# Access Compliance Report

## Public Rights-of-Way

Intersection ID: 15229	Main Street: CHARLOTTE_DR	Cross Street: IDEAL_WY	Location:	E
ADA ID: 418E17963C68	Ramp Type: PerpDiag	Initial Pass/Fail: Fail	Overall Compliance: No	Severity Score: 25
Codes/Mitigation Info/Possible Solution		Field Measurements/Component Compliance

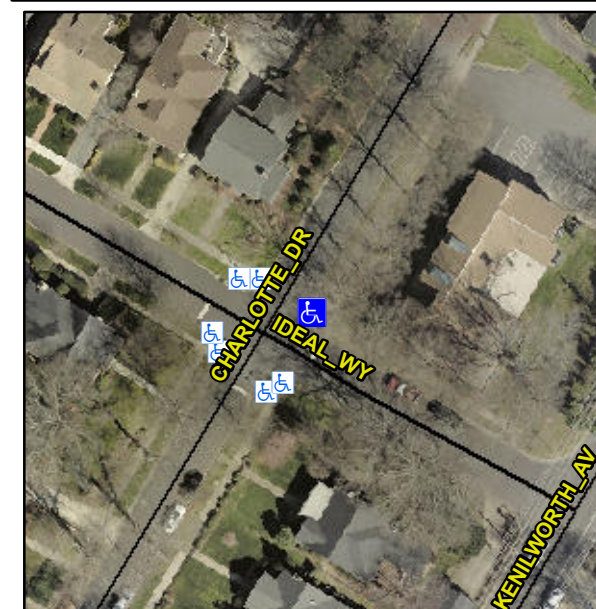
**Not Found, R304.5.3**

Compliance	Description	Data	Compliance	Description	Data
N/A	Ramp Length (in)	88.0	Yes	Ramp Slope (%)	6.4
Yes	Ramp Width (in)	48.0	No	Ramp XSlope (%)	7.6
N/A	Flare Type LT	N/A	N/A	Flare Type RT	N/A
N/A	Flare Slope LT (%)	N/A	N/A	Flare Slope RT (%)	N/A
N/A	Flare Traversable LT?	N/A	N/A	Flare Traversable RT?	N/A
N/A	Landing Length (in)	N/A	N/A	DWS Provided?	N/A
N/A	Landing Width (in)	N/A	N/A	DWS Contrast?	N/A
N/A	Landing Slope (%)	N/A	N/A	DWS Length (in)	N/A
N/A	Landing X Slope (%)	N/A	N/A	DWS Full Width?	N/A
N/A	Landing Curb? (Y/N)	N/A	N/A	DWS Offset (in)	N/A
N/A	Shared Landing?	N/A			
N/A	Gutter Ponding?	N/A	N/A	Gutter Slope (%)	N/A
N/A	Gutter Lip Ht (in)	N/A	N/A	Gutter X Slope (%)	N/A
N/A	Painted X Walk1?	No	N/A	Painted X Walk2?	No
	X Walk 1 Direction	To NW		X Walk 2 Direction	To SW
N/A	X Walk 1 Width (in)	N/A	N/A	X Walk 2 Width (in)	N/A
	X Walk 1 Slope (%)	3.8		X Walk 2 Slope (%)	10.3
	X Walk 1 X Slope (%)	6.5		X Walk 2 X Slope (%)	1.1

**Remove & Replace Curb Ramp With Two New Directional Ramps or Equivalent.**
